PCN-20210129 CR00140-02 Kit SoM Update

Company	Trenz Electronic GmbH
PCN Number	PCN-20210129
Title	CR00140-02 Kit SoM Update
Subject	BOM change
Issue Date	2021-01-29

#2 Change SoM from TE0720-03-1CFA to TE0720-03-61C33FA

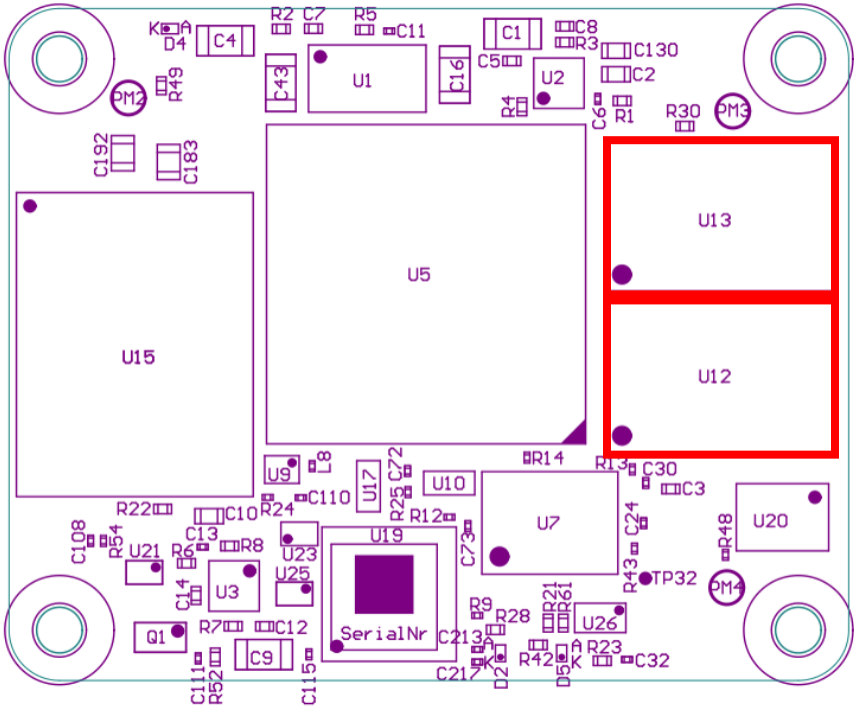
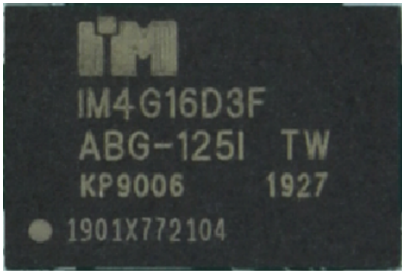
Reason: The SoM is updated due to EOL of components.

Impact: DDR3, Flash and eMMC of SoM are changed. For exact changes and impact see [PCN-20210126a TE0720-03 DDR3, Flash, EMMC Change and Product Update \(Revised\)](#).

As mentioned in [PCN-20210126a TE0720-03 DDR3, Flash, EMMC Change and Product Update \(Revised\)](#) the most prominent change for identification is the DDR3 RAM of the SoM. Locate DDR3 RAM (U12, U13) at top side of PCB:

old	new
IM4G16D3FABG-125I	IS43TR16256BL-125KBLI
